AGENDA
PLANNING COMMISSION
116 WEST NEEDLES
BIXBY, OKLAHOMA
September 21, 2015 6:00 PM

(42) 2. **Preliminary Plat & Final Plat – "Chateau Villas" – Cedar Creek Consulting (PUD 81).** Discussion and consideration of a Preliminary Plat, a Final Plat, and certain Modifications/Waivers for "Chateau Villas," approximately 23 acres in part of the NW/4 NW/4 of Section 01, T17N, R13E.
Property Located: 12303 S. Memorial Dr. and the 8300-block of E. 121st St. S.

(71) 3. **BSP 2015-06 – "Chateau Villas" – Cedar Creek Consulting (PUD 81).** Discussion and possible action to approve a PUD Detailed Site Plan and building plans for "Chateau Villas," a Use Unit 8 multifamily residential and commercial development for approximately 23 acres in part of the NW/4 NW/4 of Section 01, T17N, R13E.
Property Located: 12303 S. Memorial Dr. and the 8300-block of E. 121st St. S.

(118) 4. (Continued from 05/18/2015, 07/20/2015, & 08/17/2015)
BSP 2015-05 – "Jiffy Lube Office Building" – W Design, LLC (PUD 54). Discussion and possible action to approve a PUD Detailed Site Plan and building plans for "Jiffy Lube Office Building," a Use Unit 11 office with incidental storage building development for approximat

DATE 08/21/2015
JOB NO. 564315
DRAWN BY: TWH
SHEET NO. L1.00

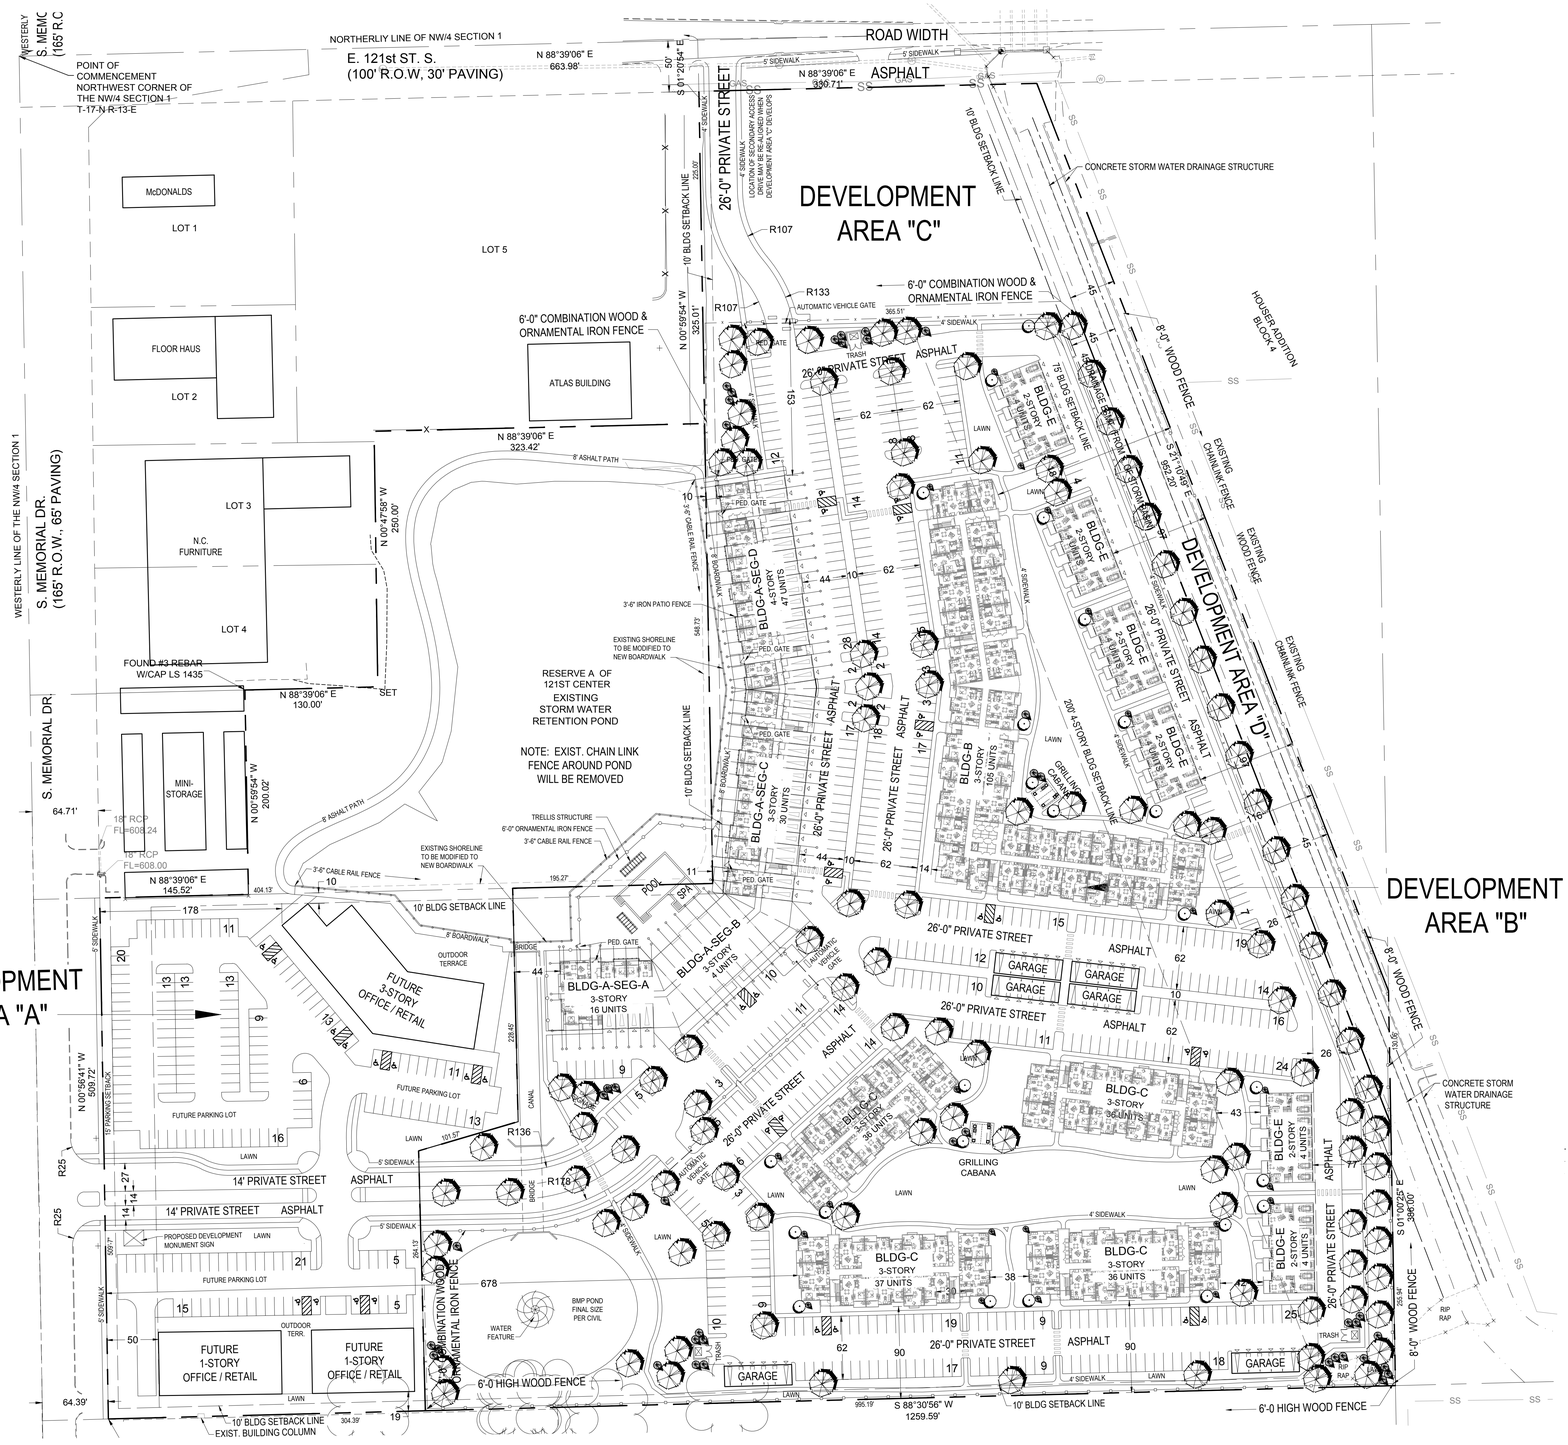
9. Irrigation Standards (Section 11-12-3.D.2): Zoning Code Section 11-12-4.A.7 requires the submission of plans for irrigation. Note # 4 (and perhaps others) on the landscape plan indicates a plan to have a plan for irrigation, and that drawing L3.00 will include a "description" of the system. An irrigation plan was not found. Drawing L3.00 was not included, so it cannot be determine if it is the required irrigation plan. **This standard is not met.**

f. Planting instructions, as customary and required per Section 11-12-4.A.5, appear to be incomplete. General Note #s 4 and 6 refer to drawing L3.00, which was not provided. Instructions should demonstrate satisfaction of applicable standards found in Section 11-12-3.D.

83. The landscaping trees proposed along the west side of the drainage channel in DA D are now fewer than as represented on the PUD site plan Exhibit B1 (approximately 73 versus 42 using one accounting method). As this PUD boundary is critical from a screening/buffering standpoint, Staff recommends no fewer trees here than were represented on Exhibit B1.

DATE
08/21/2015
JOB NO.
564315
DRAWN BY:
TWH
SHEET NO.
SP1.10

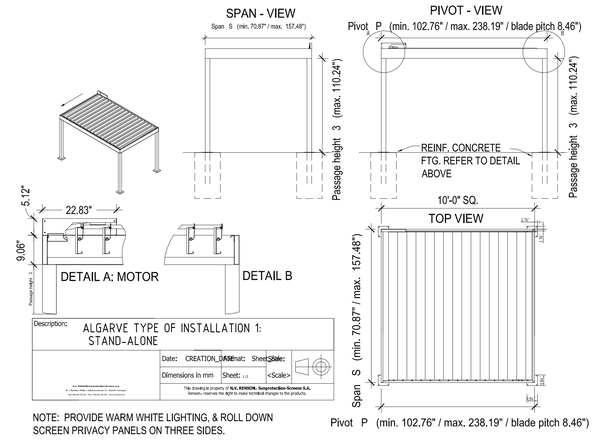
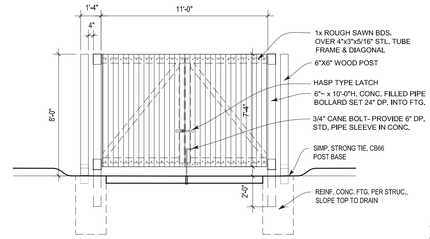
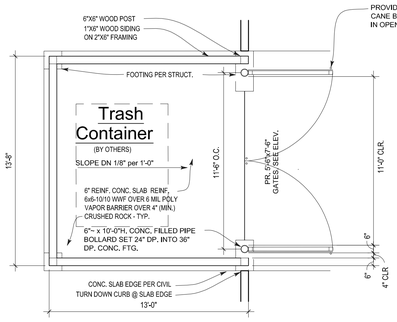
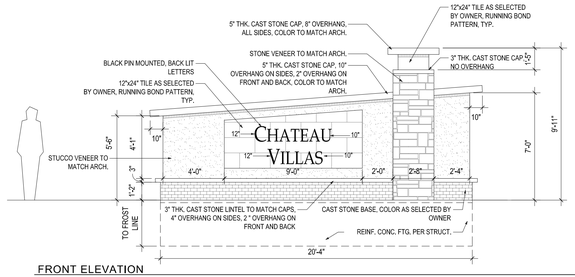
The screened dumpster area locations are identified on the site plans, and their locations appear appropriate. Per the elevations / profile view detail diagrams on drawing SP1.10, they will be 8' in height and be composed of 1" X 6" wood siding hung on 6" X 6" wood posts and gates secured by 6" [diameter] X 10'-high concrete-filled pipe bollards. The diagram does not clearly specify the material to be used for the gates, such as is necessary to demonstrate compliance with the opacity requirement of PUD 81.

The locations of six (6) garage buildings are indicated on the site plan, and their elevations / profiles are detailed on drawing SP1.10. They appear to be lap-siding buildings with some brick/stone [veneer] and a shed roof of unknown material or pitch. The exterior materials are not provided. A note provides, "All materials to match arch." As buildings, they are subject to the 40% project average minimum masonry standard of Development Area B of PUD 81. The missing information needs to be provided and the Applicant should confirm that the 40% project average minimum masonry standard is met with same included.

Drawing SP1.10 provides an "Entry Monument" detail diagram, which does not match the label or symbols used for either the "Signage" at the entrance to the multifamily development area or the "Proposed Development Monument Sign" at the Memorial Dr. entrance to the entire development. If the "Entry Monument" is intended for the latter, it will comply with the signage provisions of PUD 81 for Development Area A. The sign appears to be 9' 11" in height and composed of stucco with a cast stone base (which resembles brick), a stone veneer columnar accent, copy reading "CHATEAU VILLAS" against a tile background, and cast stone cap and lintel.

108. Elevations drawings: Project Totals: Please correct typos in term "Alternative[s]."
109. Drawing SP1.10: Detail diagram appears to represent "trellis" structures as indicated on the site plan, but named "pool cabana" on detail diagram. Please reconcile.

116. "Entry Monument" detail diagram on SP1.10 does not match label or symbols used for either the "Signage" at the entrance to the multifamily development area or the "Proposed Development Monument Sign" at the Memorial Dr. entrance to the entire development. Please reconcile as appropriate.

DATE
08/21/2015
JOB NO.
564315
DRAWN BY:
TWH
SHEET NO.
SP1.11

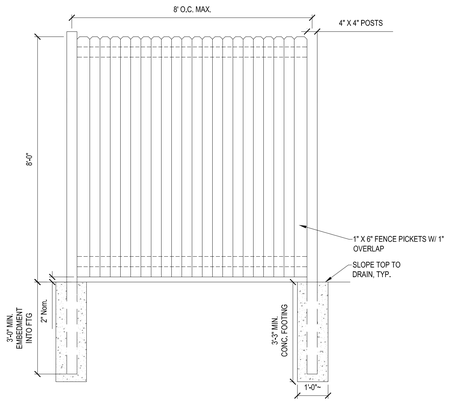
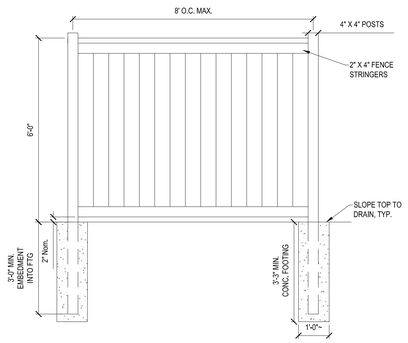
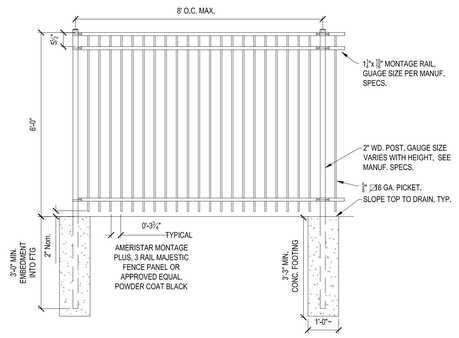
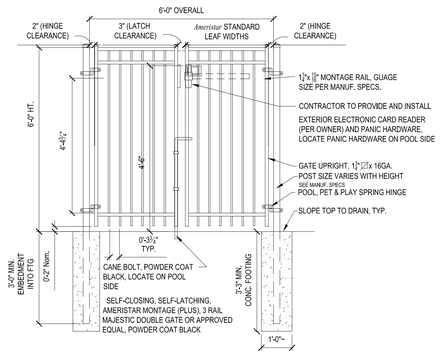
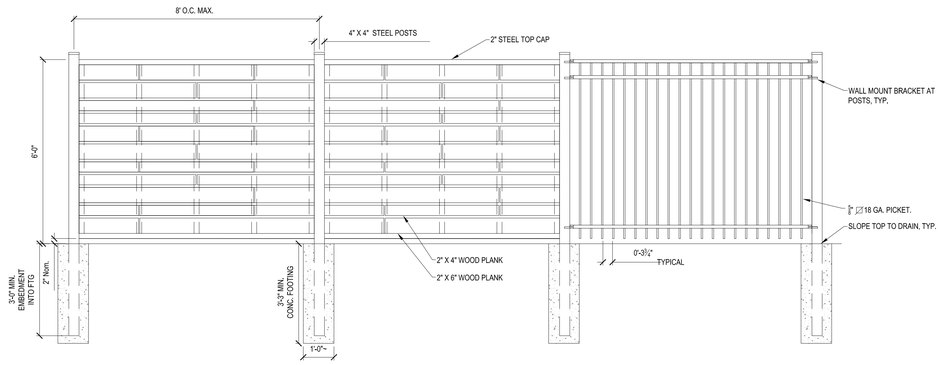
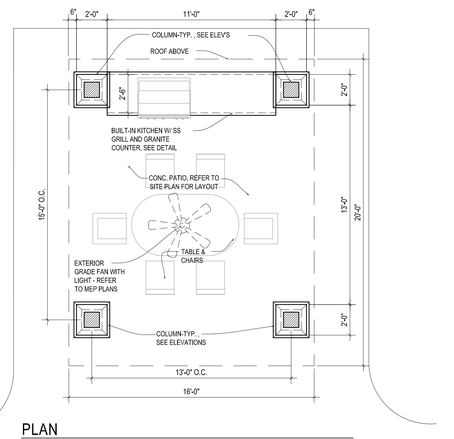
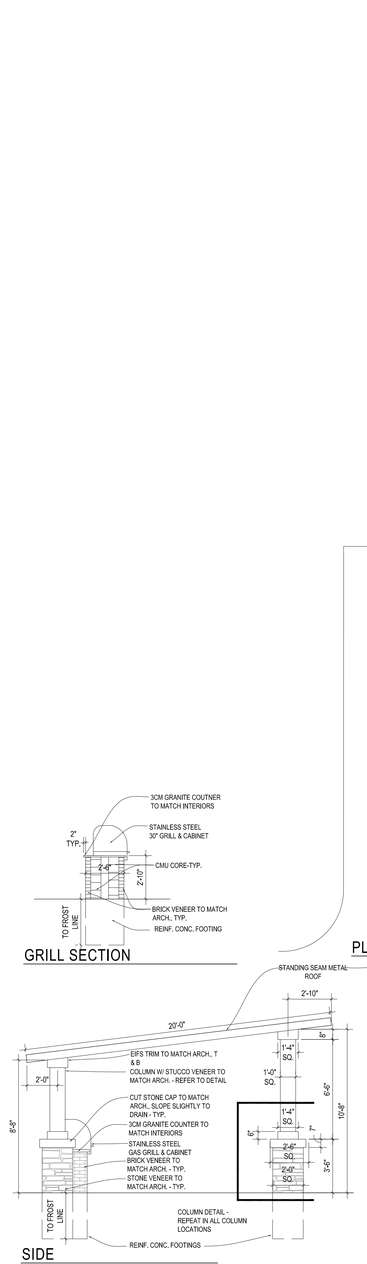
The masonry columns, per the PUD Text, are not shown on the wrought / ornamental iron fence elevation / profile view detail diagrams on drawings SP1.11.

The locations of two (2) "Grilling Cabana" structures are indicated on the site plan, in the greenspaces between groups of apartment buildings. Their elevations / profiles are detailed on drawing SP1.11, which shows them to be covered shelters with built-in gas grills, each composed of "stone veneer," "brick veneer," "stucco veneer," with "cut stone" and "EIFS" trim, and a "standing seam metal" shed roof. They do not appear to be visible from public streets, and not particularly visible from *Houser Addition*. The plans appear to be in order and do not conflict with PUD 81.

70. The masonry columns, per the PUD Text, are not shown on the wrought / ornamental iron fence elevation / profile view detail diagrams on drawings SP1.11.

72. SP1.10 or SP1.11: Please add masonry wall elevation for northerly portion of Development Area D, as per other recommendations in this report.
73. PUD 68 provided that the wood fences shall be constructed with all braces and supports on the interior. Per PUD 81, this should be done for this project as well. Please provide appropriate notation.

77. Site Plan: Please correct typo in "Combination Wood and Ornamental Iron Fence" in Legend. Please search and correct any other similar instances.
78. Drawing SP1.11: Pedestrian gate detail diagram appears to be specific to pool. Please provide detail diagram for pedestrian gates used elsewhere in the development.

DATE
08/21/2015
JOB NO.
564315
DRAWN BY:
TWH / ACK
SHEET NO.
A1.16

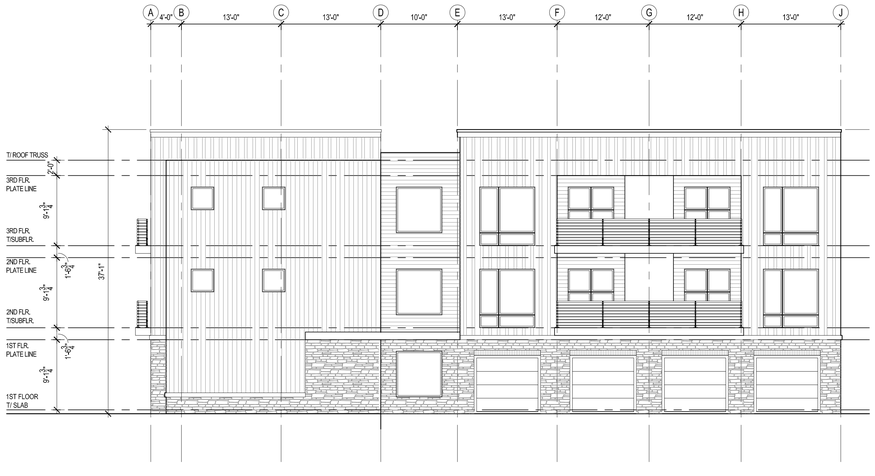
Per drawing A1.16, the front elevation for the clubhouse segment of Building A reflects "Club Signage," but dimensions are not provided. If intended as a placeholder for a future sign design, it should be so noted. No other wall signs are indicated.

120. Per drawing A1.16, the front elevation for the clubhouse segment of Building A reflects "Club Signage," but dimensions are not provided. If intended as a placeholder for a future sign design, it should be so noted.

DATE
08/21/2015
JOB NO.
564315
DRAWN BY:
TWH / ACK
SHEET NO.
A1.42

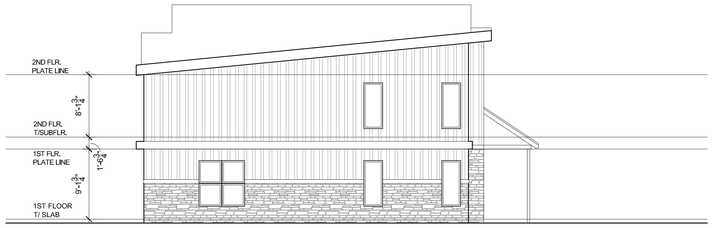
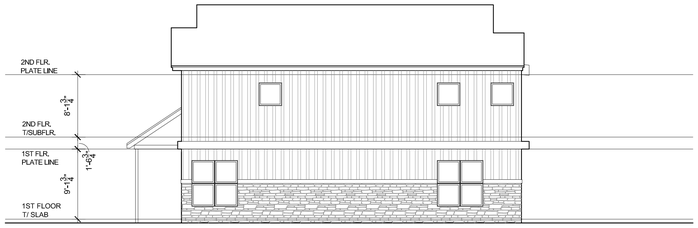
111. Elevations drawing A1.42: Represent façades of "Carriage Homes," which appear to correspond to Building(s) [D] on the site plan. Please reconcile.

5 TRASH ENCLOSURE ELEVATION

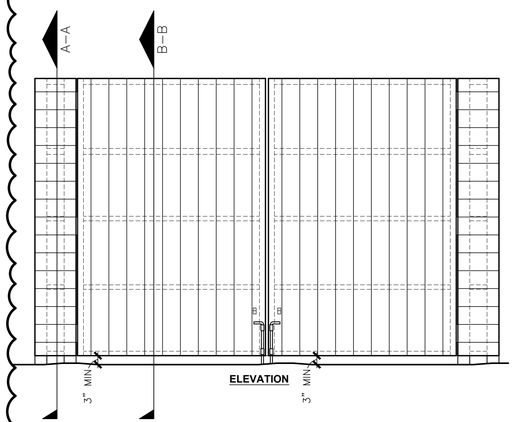
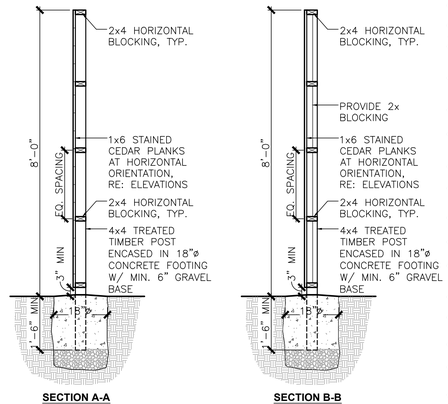
The site plan identifies one (1) trash can enclosure area, which has been relocated with the latest site plans to the southeast corner of the building, which new location also complies with the locational restriction of the PUD. The revised plans call for it to be an 8'-high cedar wood dumpster enclosure, and the profile view/elevation is indicated as diagram #s 4 and 5 on drawings AS101, and appears to demonstrate compliance with the opacity requirement. As recommended, the screening height and composition details have been submitted, for the Planning Commission's review and approval as a part of this Detailed Site Plan.

1 PHOTOMETRIC SITE PLAN
SCALE: 1/16" = 1'-0"

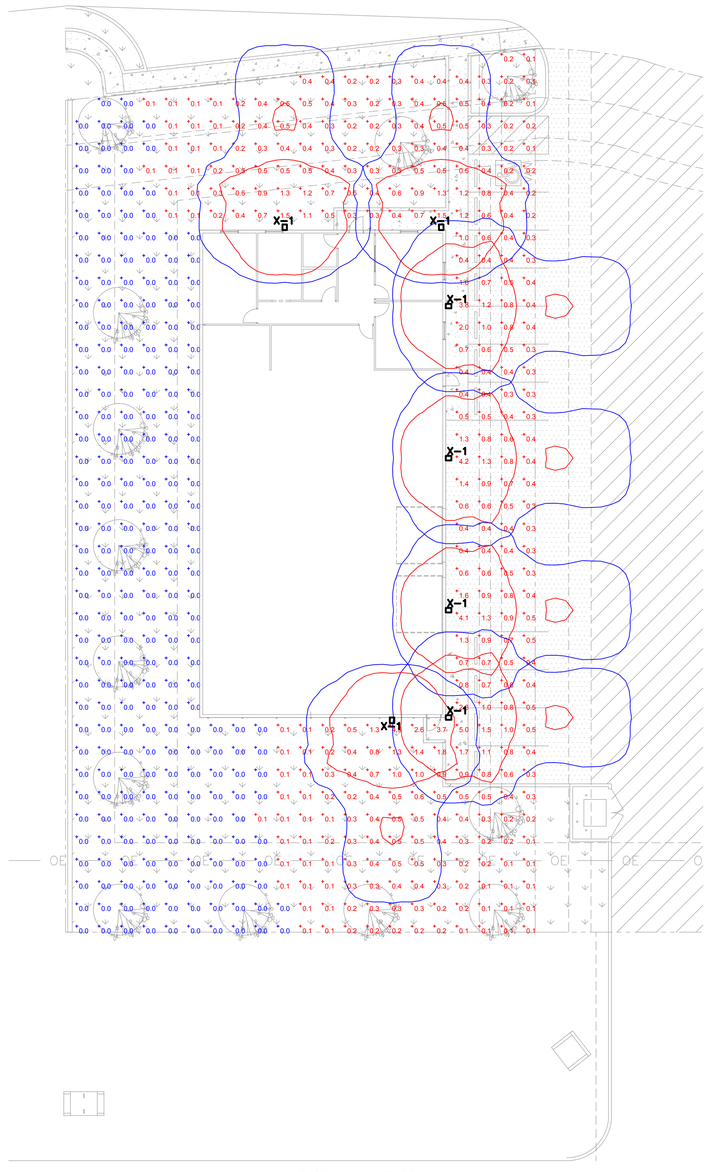
Outdoor Lighting. The Lighting Plan consists of "Photometric Site Plan" drawing AS102, which includes a photometric plan and a legend describing the different light fixtures proposed and certain other particulars. There do not appear to be any pole-mounted lights; all are building-mounted and appear typical for an office building application.

3 EAST ELEVATION 2
SCALE: 3/16" = 1'-0"

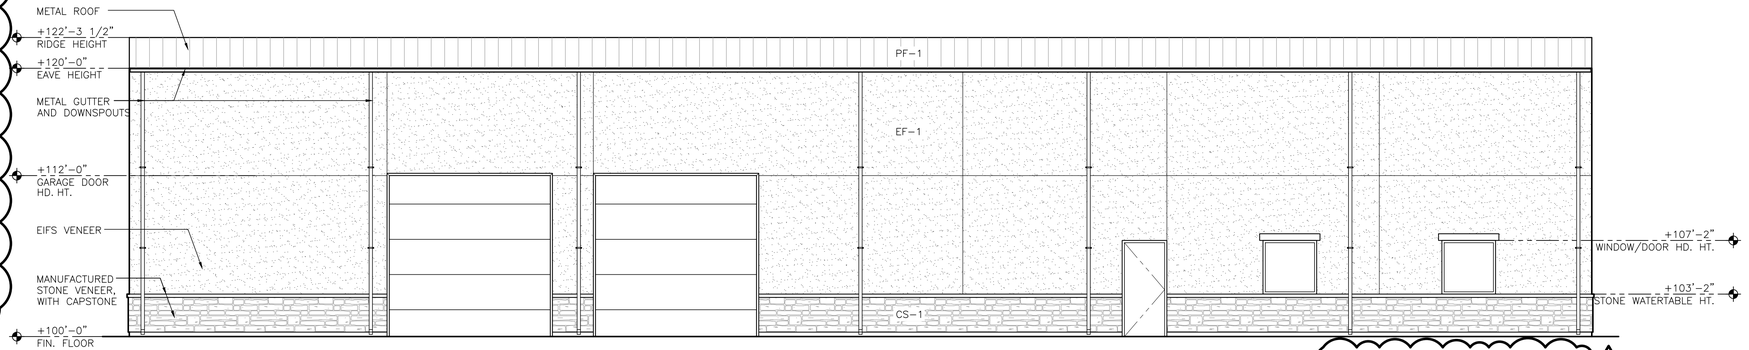
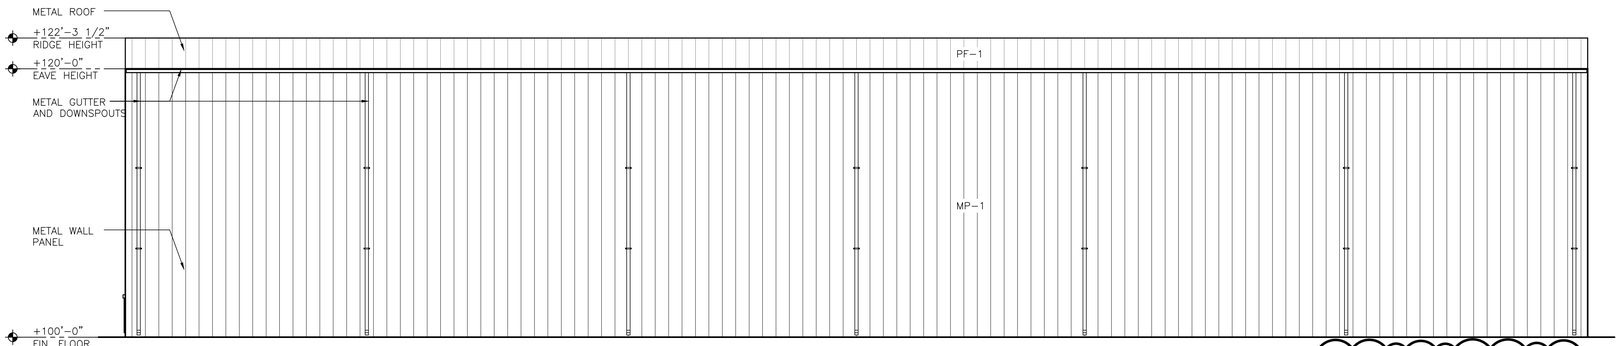
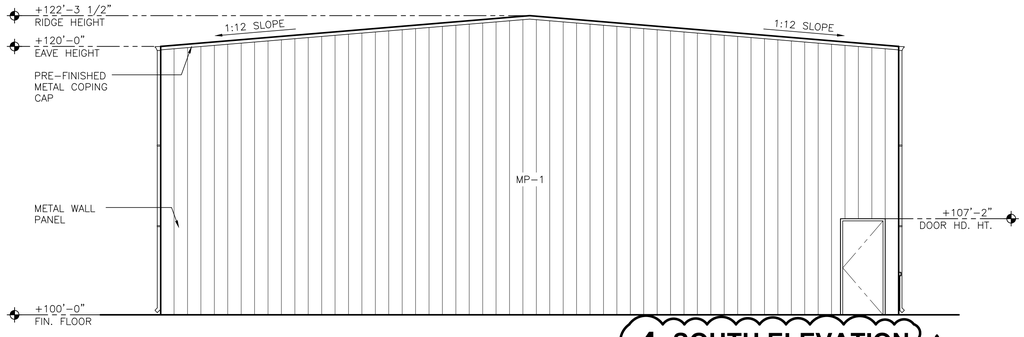
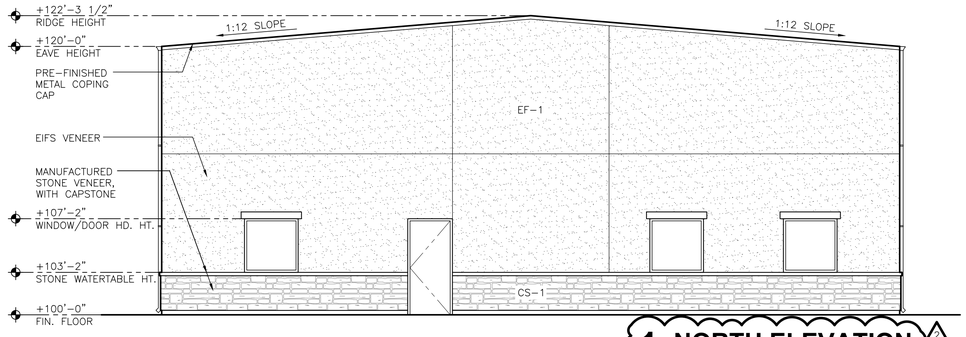
Exterior Materials and Colors. Appearance and height information is provided on the "Exterior Elevations" drawing A301. The PUD has a 35' maximum building height in Development Area B / Lot 2, Block 1, *Bixby Jiffy Lube*. The previous shed-roof design has changed, and the plans now call for a white gable roof design with a 22' 3.5" ridge height and a 1:12 pitch.
